## PRESENTATION

“ This system replaces the anti-fall baskets with a strap system.

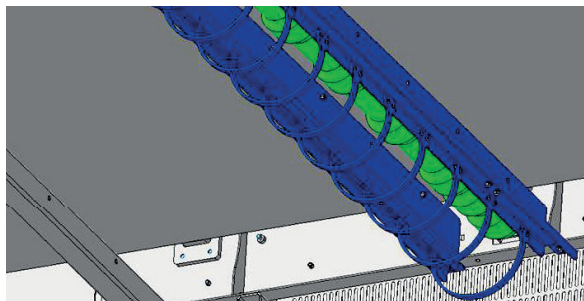
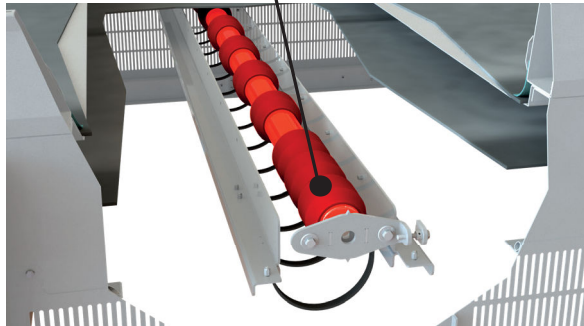
**It slows down the clogging of the return rollers and reduces the maintenance time of this sub-system.**

-> This system has the advantage of allowing dust residues to pass through while retaining the anti-fall function of the return rollers.

Compatibility with conveyor layout.  
Not compatible in case of direct access to the return rollers from underneath (walkway / work area).  
Study required to control these points.
